D. Project 2023-02 Analysis and Mitigation of BES Inverter-Based Resource Performance Issues.....	18
VI. JUSTIFICATION FOR APPROVAL: PROPOSED RELIABILITY STANDARD PRC-029-1 .....	19

**Exhibit A** Proposed Reliability Standards

- A-1 Proposed Reliability Standard PRC-024-4 – Clean
- A-2 Proposed Reliability Standard PRC-024-4 - Redline
- A-3 Proposed Reliability Standard PRC-029-1

Figure 1: Voltage Ride-Through Requirements for AC-Connected Wind Facilities

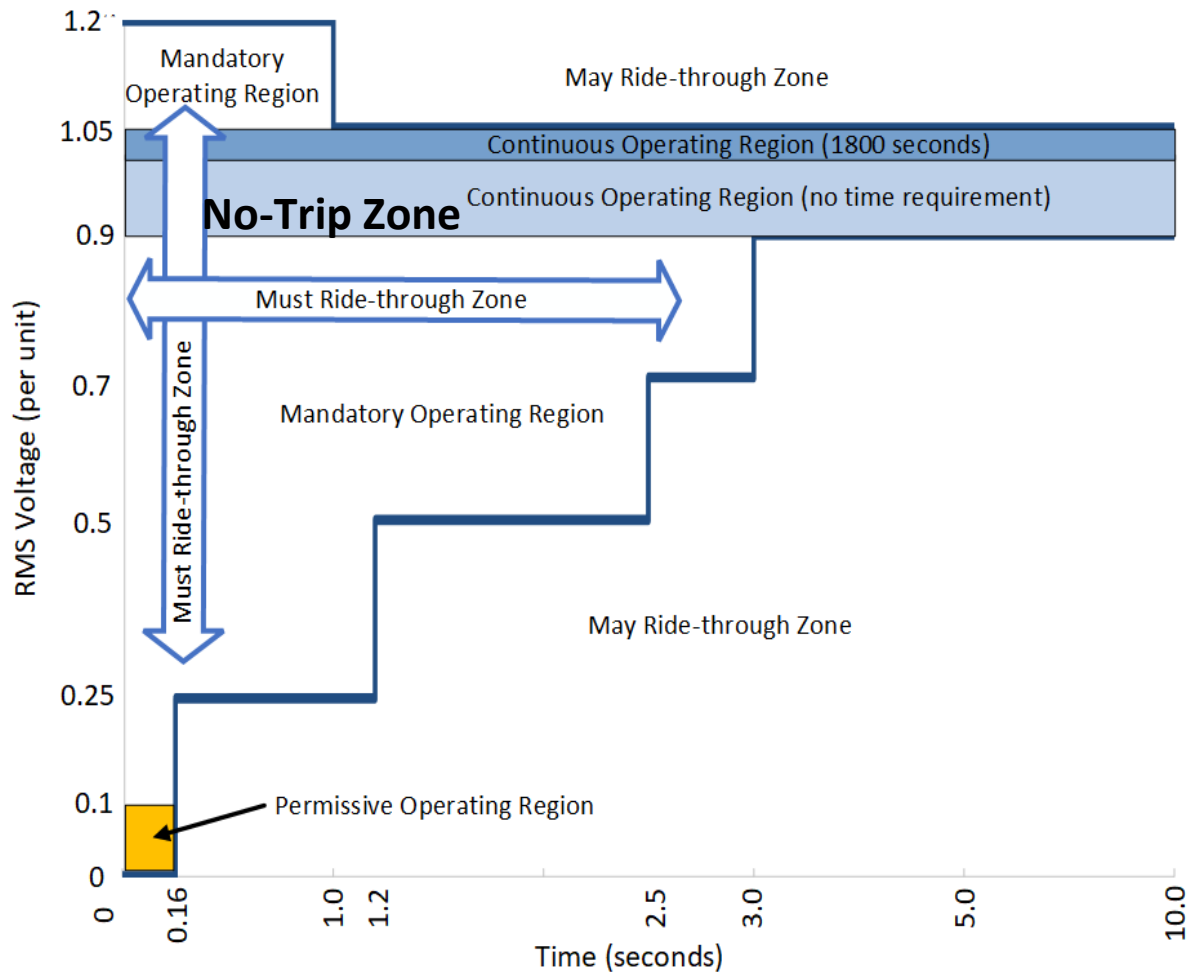
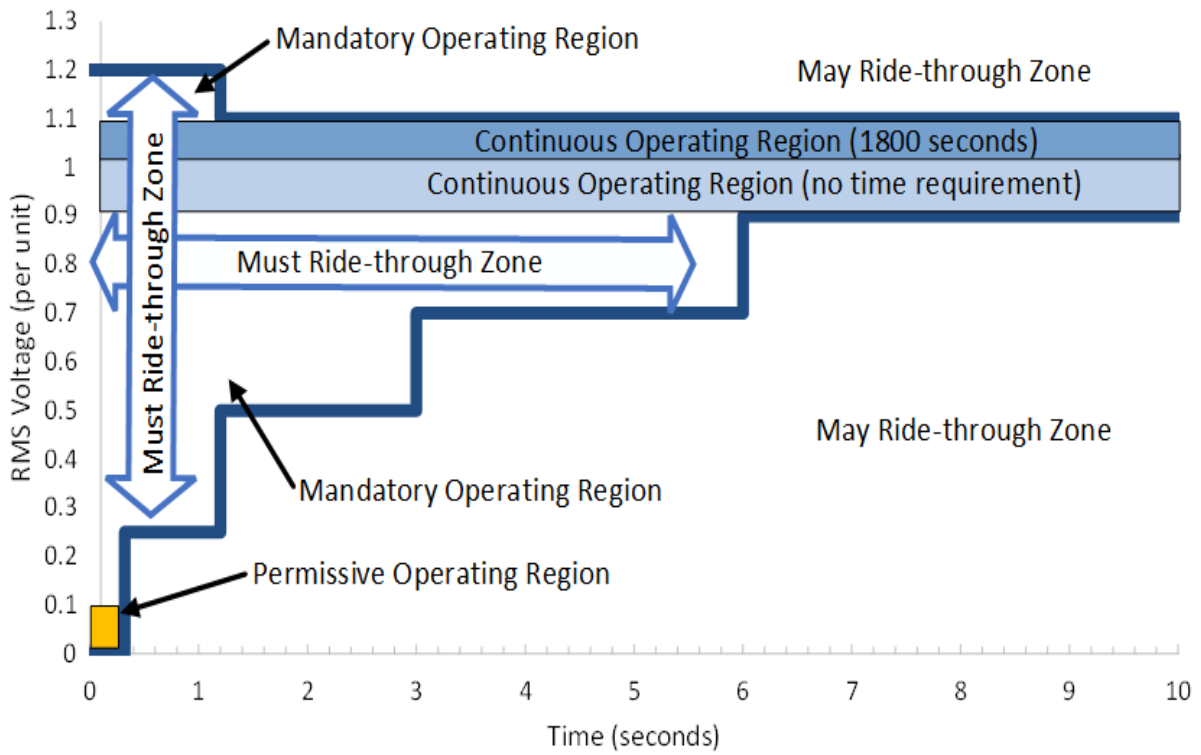
The SRC recommends that the SDT to review and align the data in **Attachment 1** to ensure that the data in Tables 1 and 2 aligns with what is shown in Figures 1 and 2. Currently, the graphs in Figures 1 and 2 do not match what is indicated in the Tables. For example, rows 1-3 in Tables 1 and 2 are identical, yet Figure 2 does not match Figure 1 by indicating a Voltage Ride-Through Requirement of 1.0.

Lastly, the values specified in Table 1 and Table 2 in Attachment 1 do not align with the graphs shown in Figure 1 and Figure 2, respectively.

There is a discrepancy between the definition of the Term “Mandatory Operating Region” which states “&le; 1.2 per unit” and Table 1/Figure 1 or Table 2/Figure 2 which state “&ge;1.200” per unit “N/A”. Please clarify if Table 1/Figure 1 and Table 2/Figure 2 should state “>1200” or if the definition of the Term “Mandatory Operating Region” should state “<1.2 per unit”.

Please clarify Figure 1 and Figure 2 to clearly show the “Continuous Operating Region”, “Mandatory Operating Region”, and “Permissive Operating Region”, along with requirements beyond 10 seconds.

R1/R2: Recommend that Attachment 1 have a chart to include the Continuous Operation Region, Mandatory Operation Region, and Permissive Operation Region or have those regions specified on existing Voltage Ride-through Requirements Figure 1 and Figure 2.
